Item Name: Quick Release Heli-Utility-Basket™ Long, HD Lid, Spacepod™/Squirrel Cheek Comp.

DART SERVICE INSTRUCTION

TO AMEND INSTALLATION INSTRUCTIONS D350-607-3 Rev.D,
INSTALLATION INSTRUCTIONS D350-607-4 Rev. C AND
INSTRUCTIONS FOR CONTINUED AIRWORTHINESS ICA-D350-607 REV. 6

REF TCCA STC: SH94-14
REF FAA STC: SR00213NY
REF EASA STC: EASA.10016996
REF BRAZILIAN STC: 2007S03-03/-04/-05/-06

FIGURE 1: INSTALLATION OF D4775-041 FWD STRUT

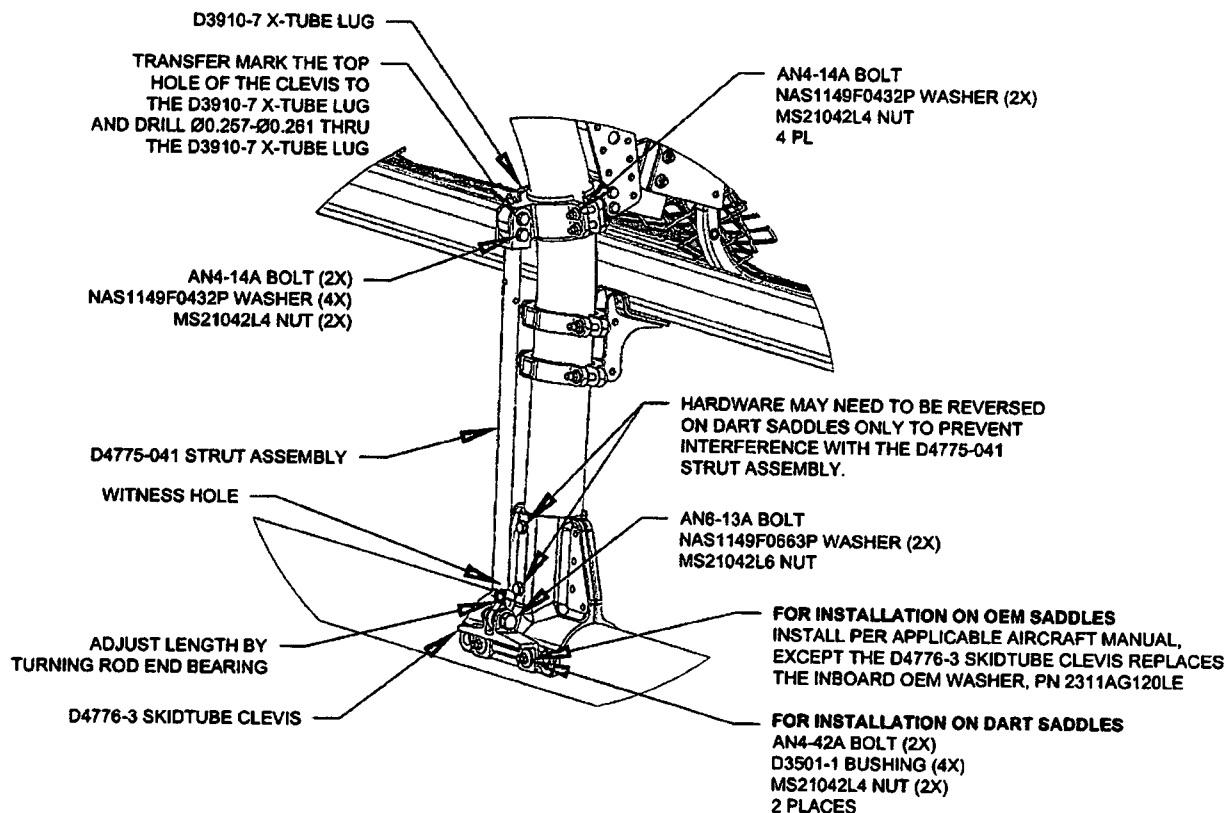
- 3.1 Substitute the Forward Lower D3910-5 X-Tube Lug with the D3910-7 X-Tube Lug as shown in Figure 1.
- 3.2 Install the forward D4775-041 Strut Assembly. Transfer mark from the upper hole on the clevis of the D4775-041 Strut Assembly to the D3910-7 X-tube Lug and drill thru the lug $\varnothing 0.257$ - $\varnothing 0.261$ as shown in Figure 1. Touch up chemical conversion coating per MIL-DTL-5541. Check the witness holes located at the bottom end of the D4775-041 Strut Assemblies to ensure that the thread from the rod end extends past the witness hole. **Torque MS21042L4/-4 nuts to 50-70 in-lbs (5.7-7.9 N-m). Torque MS21042L6/-6 nuts to 160-190 in-lbs (18.1-21.5 N-m).**
- 3.3 Complete the installation in accordance with Installation Instructions D350-607-3 Rev. D or D350-607-4 Rev. C.
